KPA500 KIT ASSEMBLY MANUAL ERRATA

Rev. F6-2, September 24, 2016

E740149E

Figure 34. Connecting the 270V Wire to the PA/LPF Module.

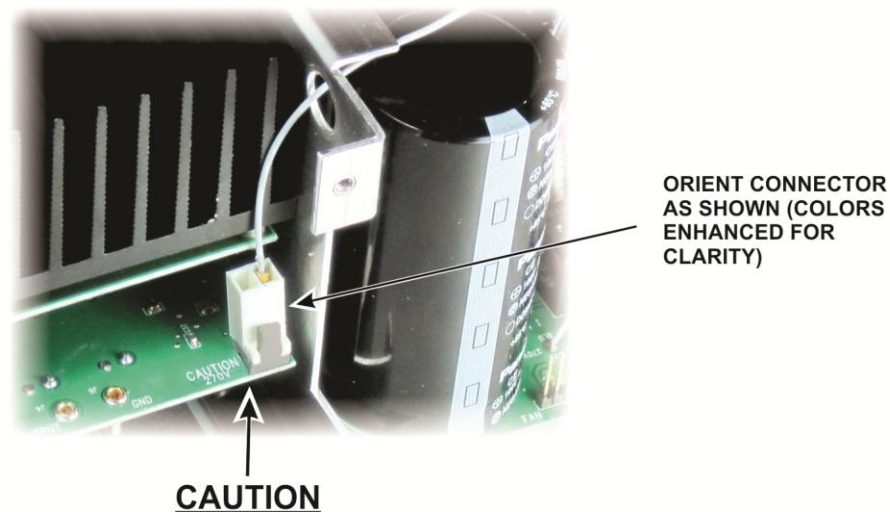
1. Page 25, replace the last check box step and Figure 34 with the following:

Connect the 270V wire from the power supply module to the PA/LPF module as shown in Figure 34. **Support the pc board so it does not flex while mating the connector.** This is the connector you routed through the hole in the Z-bracket earlier.

CAUTION
SUPPORT THE BOARD FROM BELOW WITH YOUR FINGERS
WHILE ATTACHING THE CONNECTOR SO THE BOARD CANNOT FLEX.
ALLOWING THE BOARD TO FLEX MAY BREAK COMPONENTS ON THE BOARD.
